# CONTRACT

Letting Date: August 18, 2015 Contract ID: 78-0801-366 Bid Order No.: 303  
County: POTTAWATTAMIE Project Engineer: COUNCIL BLUFFS RCE  
Cost Center: 601000 Object Code: 890 DBE Commitment \$0.00  
Contract Work Type: GRADING

PROJECT: IMN-029-3(127)48--0E-78 COUNTY: POTTAWATTAMIE  
WORK TYPE: RCB CULVERT NEW - SINGLE BOX ACCOUNTING ID: 32831  
ROUTE: I-29 LENGTH (MILES): 0  
LOCATION: COUNCIL BLUFFS INTERSTATE SYSTEM  
UNDER CBEC R.R.  
NON-FEDERAL AID - PREDETERMINED WAGES ARE NOT IN EFFECT  
PROJECT AMOUNT: \$476,937.80

PROJECT: IMN-080-1(366)4--0E-78 COUNTY: POTTAWATTAMIE  
WORK TYPE: GRADING ACCOUNTING ID: 32832  
ROUTE: I-80 LENGTH (MILES): 0  
LOCATION: IAIS R.R. IN COUNCIL BLUFFS  
NON-FEDERAL AID - PREDETERMINED WAGES ARE NOT IN EFFECT  
PROJECT AMOUNT: \$12,765,595.97

SHEET NO. M.12

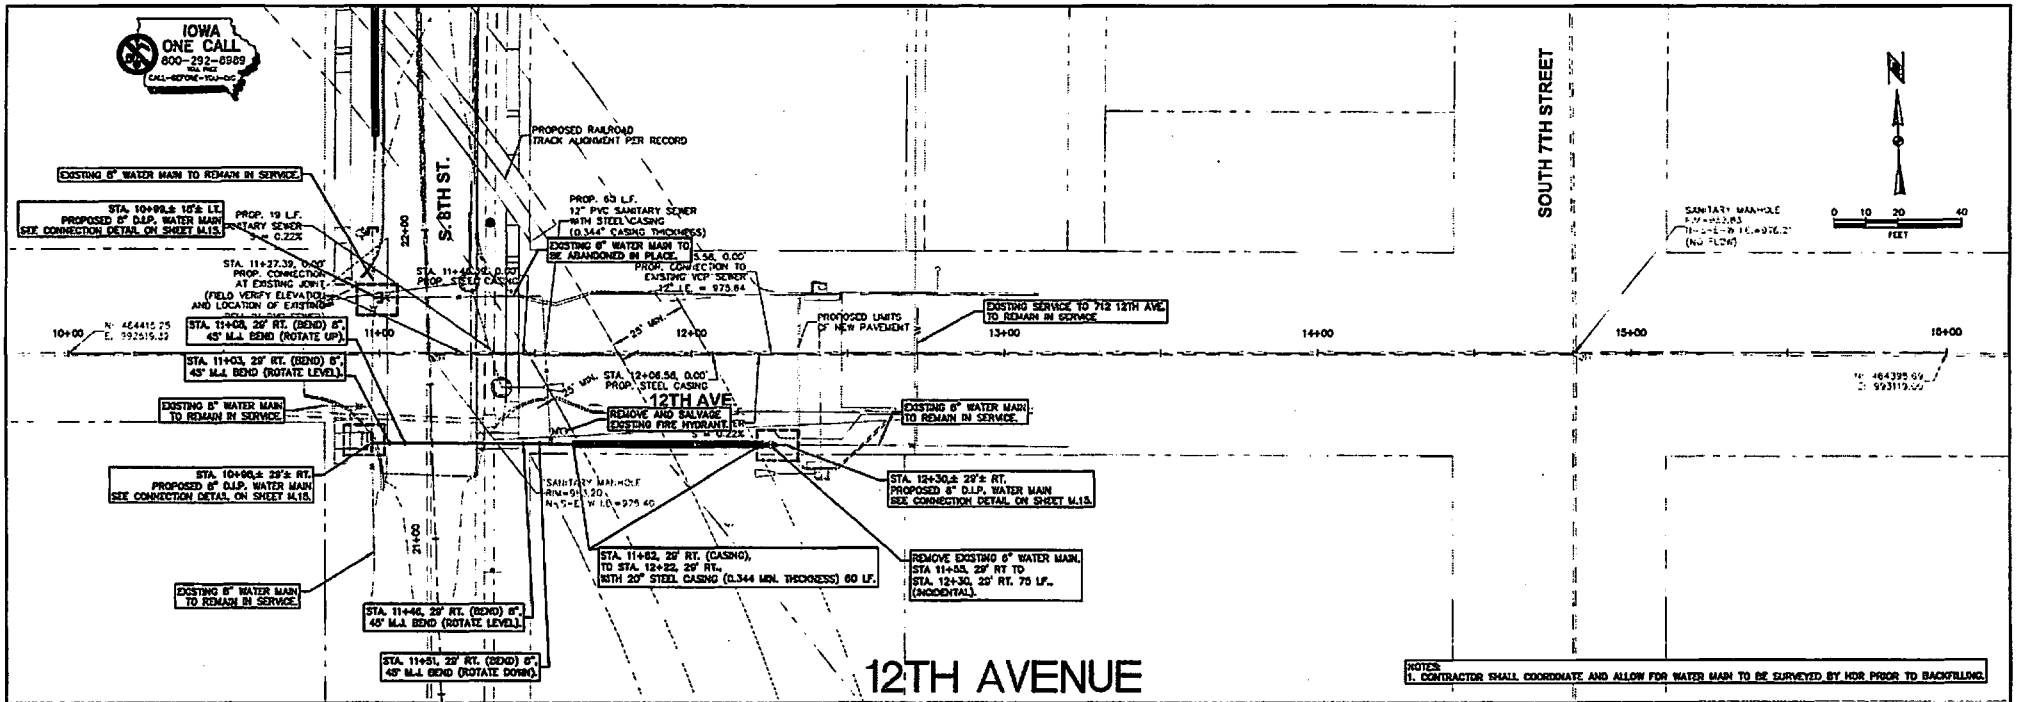
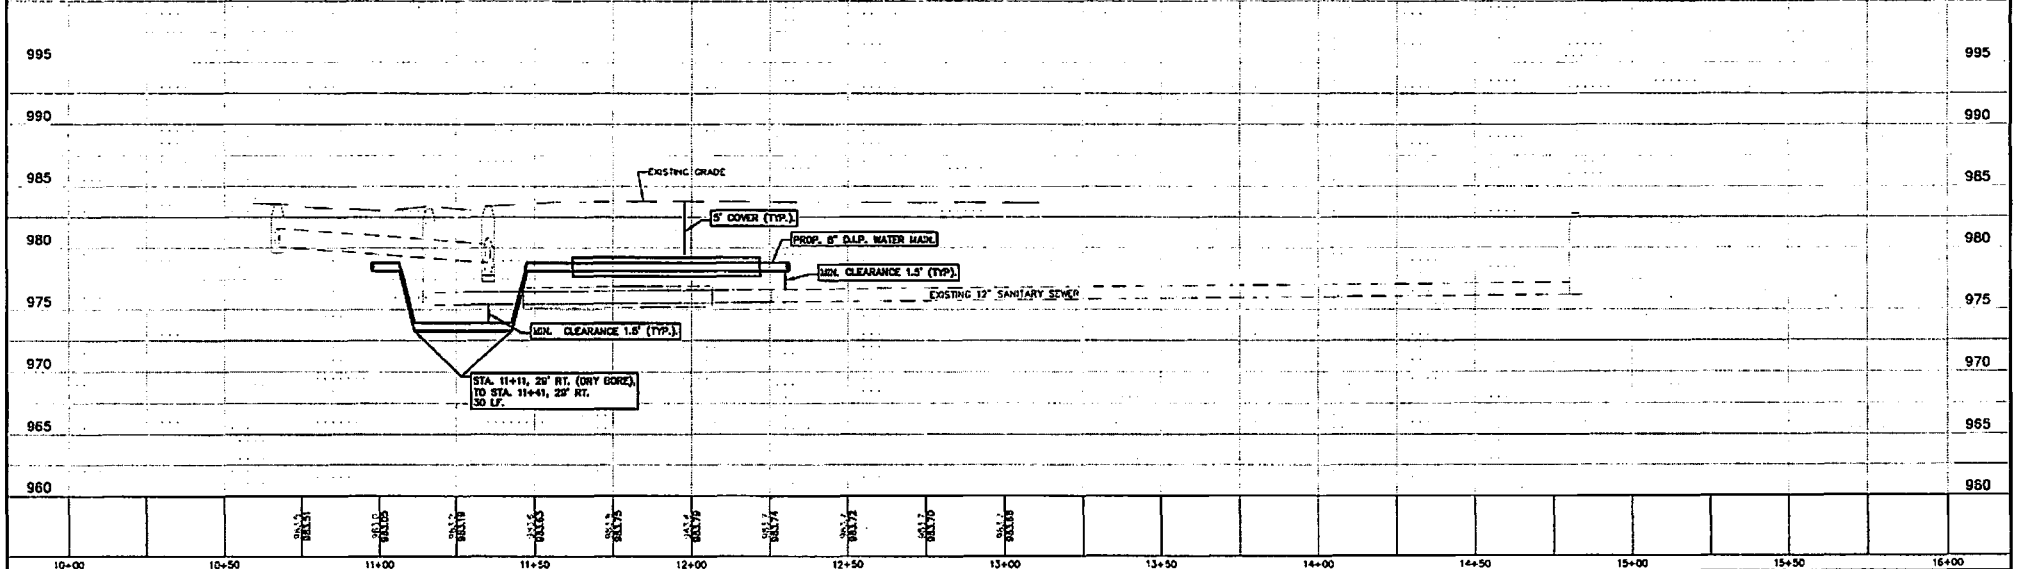
Replace plan sheet M.6, M.7, & M.8 with the attached:

Add plan sheets M.9 thru M.15 to the plans:

Additional plan sheets M.6 – M.10 and M.11 – M15 for sanitary sewer relocation at 20<sup>th</sup> Avenue and water main relocation in the area of 8<sup>th</sup> Street and 12<sup>th</sup> Avenue.
